Access Compliance Report

Public Rights-of-Way

Intersection ID: 50579	Main Street: GREAT_LAUREL_RD	Cross Street: PAPER_TREE_RD	Location: NE
ADA ID: C218BB5342F8	Ramp Type: Perp	Initial Pass/Fail: Fail	Overall Compliance: No
Severity Score: 22.5			
Codes/Mitigation Info/Possible Solution		Field Measurements/Component Compliance

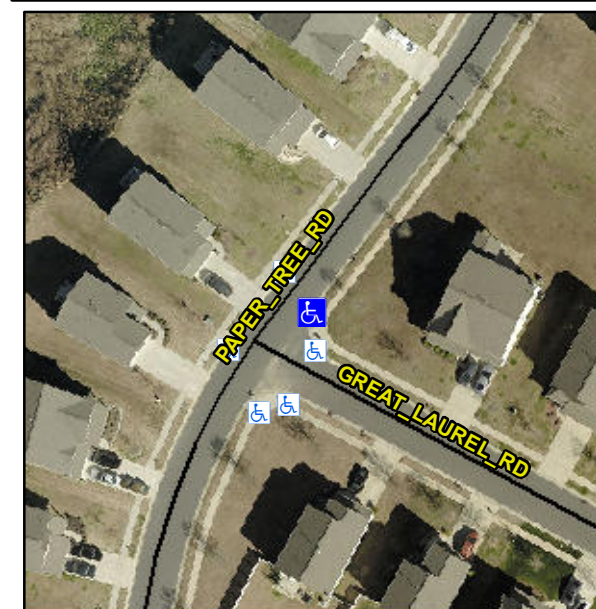
R304.5.1, R304.2.2, R304.5.3

Compliance	Description	Data	Compliance	Description	Data
N/A	Ramp Length (in)	48.0	No	Ramp Slope (%)	9.6
No	Ramp Width (in)	45.5	No	Ramp XSlope (%)	3.1
N/A	Flare Type LT	N/A	N/A	Flare Type RT	N/A
N/A	Flare Slope LT (%)	N/A	N/A	Flare Slope RT (%)	N/A
N/A	Flare Traversable LT?	N/A	N/A	Flare Traversable RT?	N/A
N/A	Landing Length (in)	N/A	N/A	DWS Provided?	N/A
N/A	Landing Width (in)	N/A	N/A	DWS Contrast?	N/A
N/A	Landing Slope (%)	N/A	N/A	DWS Length (in)	N/A
N/A	Landing X Slope (%)	N/A	N/A	DWS Full Width?	N/A
N/A	Landing Curb? (Y/N)	N/A	N/A	DWS Offset (in)	N/A
N/A	Shared Landing?	N/A			
N/A	Gutter Ponding?	N/A	N/A	Gutter Slope (%)	N/A
N/A	Gutter Lip Ht (in)	N/A	N/A	Gutter X Slope (%)	N/A
N/A	Painted X Walk1?	No	N/A	Painted X Walk2?	N/A
	X Walk 1 Direction	To NW		X Walk 2 Direction	N/A
N/A	X Walk 1 Width (in)	N/A	N/A	X Walk 2 Width (in)	N/A
	X Walk 1 Slope (%)	2.0		X Walk 2 Slope (%)	N/A
	X Walk 1 X Slope (%)	2.2		X Walk 2 X Slope (%)	N/A

Remove & Replace Entire Ramp.
